CONTRACT CHANGE ORDER NO. 122
SHEET 2 OF 9

MARK	DATE	DESCRIPTIONS	BY	CH'D	CCO#
1	07/31/09	LONGITUDINAL SHEAR PLATE	DT	GB	122

SAN FRANCISCO OAKLAND BAY BRIDGE
EAST SPAN SEISMIC SAFETY PROJECT
SELF-ANCHORED SUSPENSION BRIDGE
(SUPERSTRUCTURE & TOWER)

GIRDER AT EAST TRANSITION NO. 16

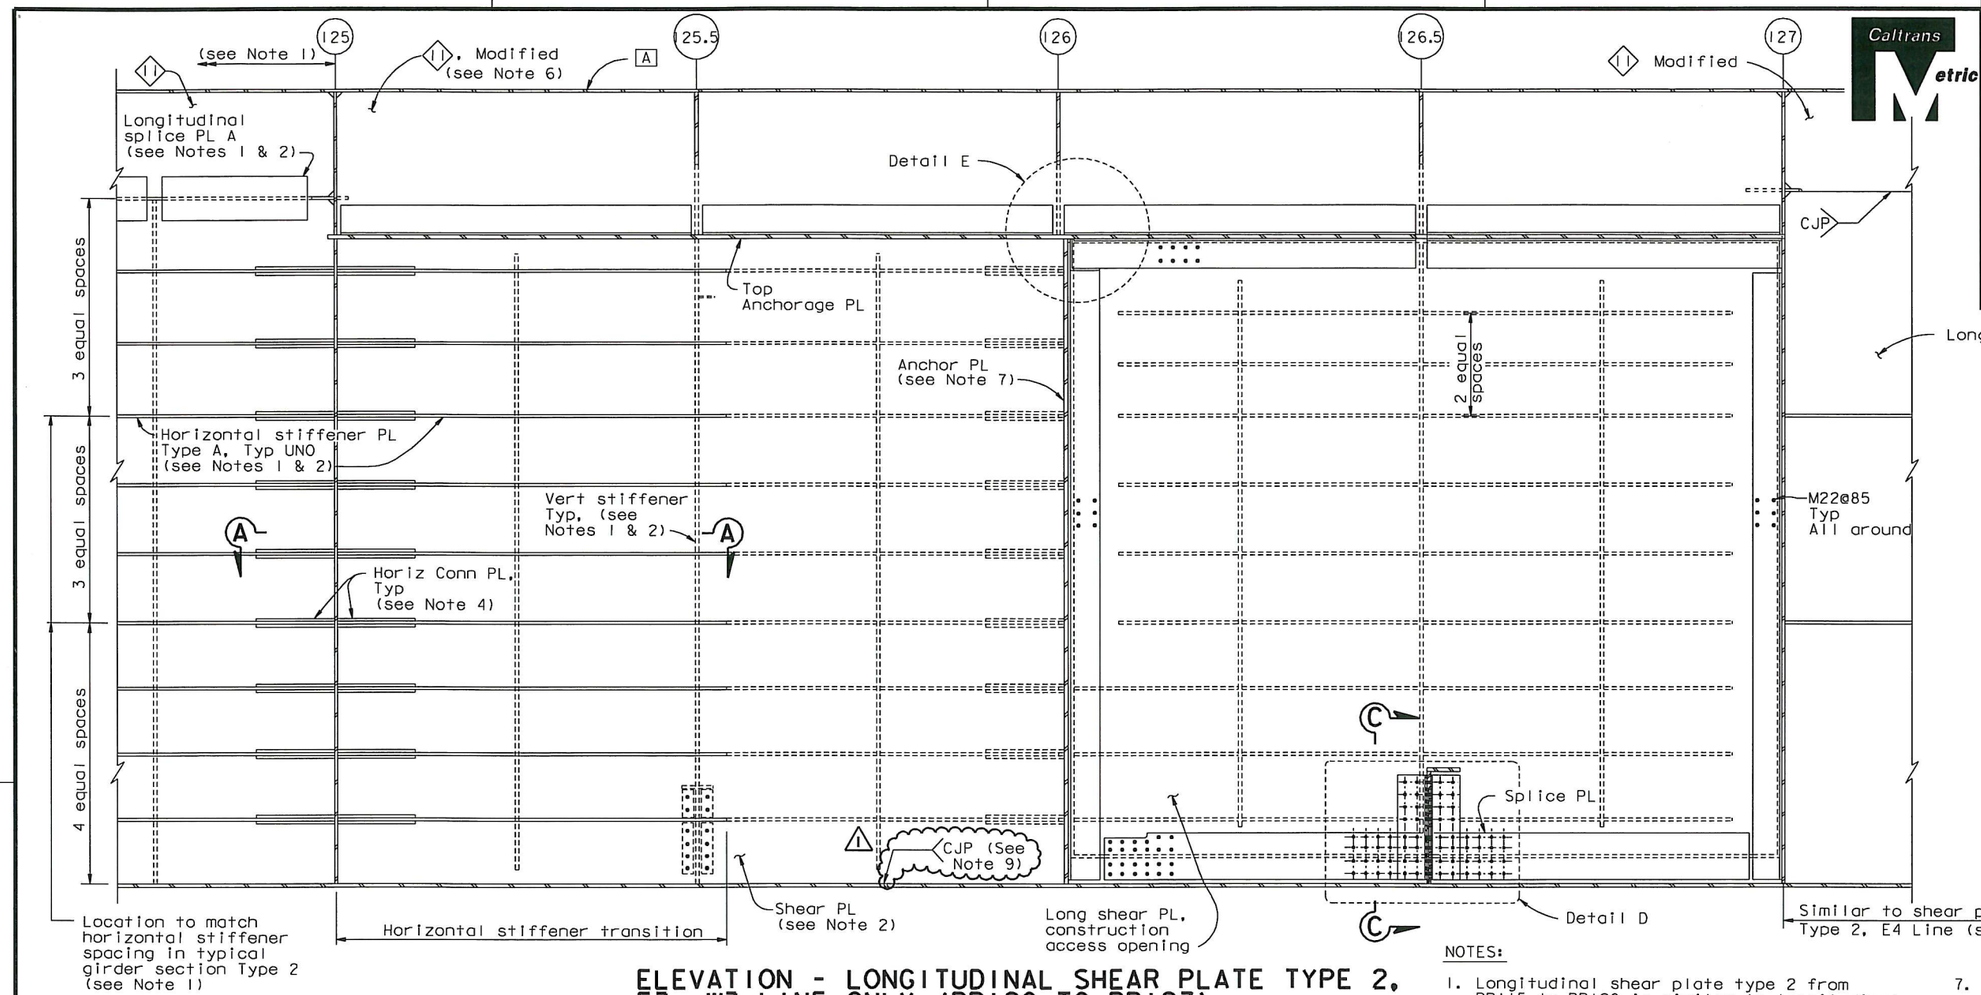
MARK	DATE	DESCRIPTIONS	BY	CH'D	CCO#
1	07/31/09	LONGITUDINAL SHEAR PLATE	DT	GB	122

8. For Sections A-A, C-C and Details D and E, see "Girder At East Transition Details No. 4" sheet.
9. The Longitudinal Shear Plate to Girder Face "D" weld shall be a CJP from the CL Splice near PP111 to PP128.7.

SAN FRANCISCO OAKLAND BAY BRIDGE
EAST SPAN SEISMIC SAFETY PROJECT
SELF-ANCHORED SUSPENSION BRIDGE
(SUPERSTRUCTURE & TOWER)
GIRDER AT EAST TRANSITION DETAILS NO. 4

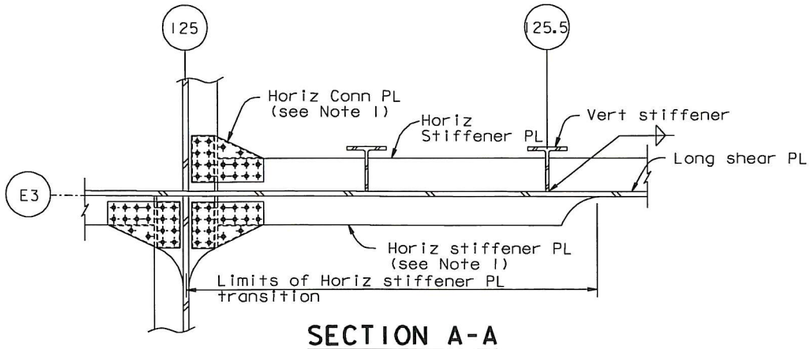
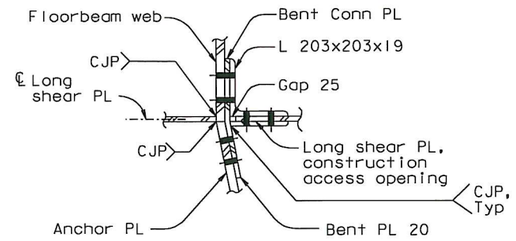
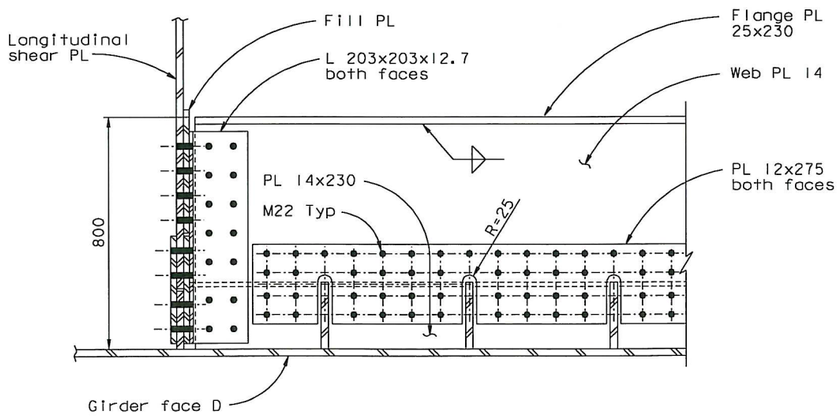
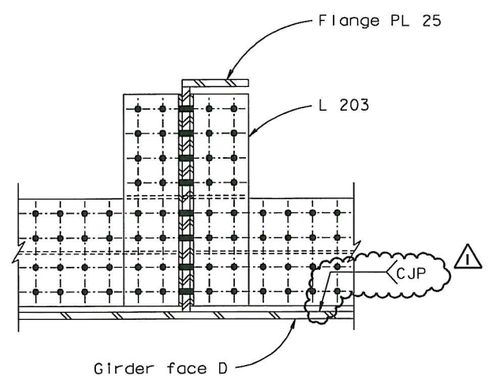
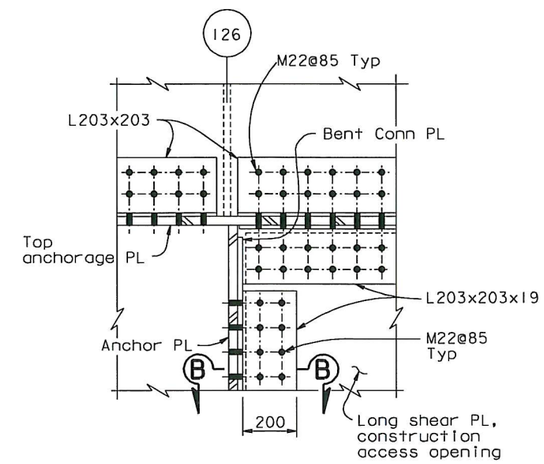
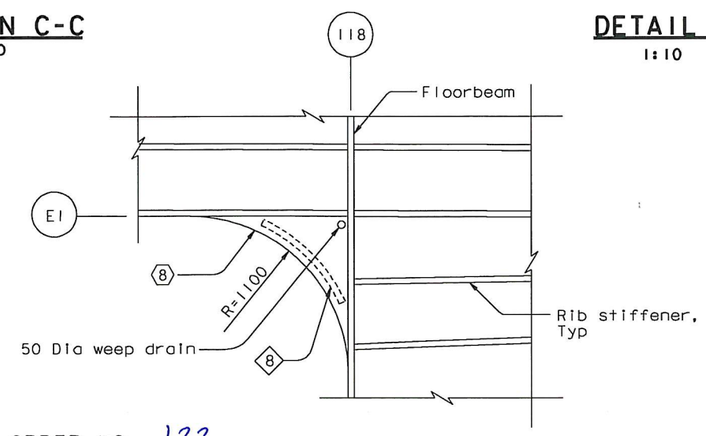
MARK	DATE	DESCRIPTIONS	BY	CH'D	CCO#
1	07/31/09	LONGITUDINAL SHEAR PLATE	DT	GB	122
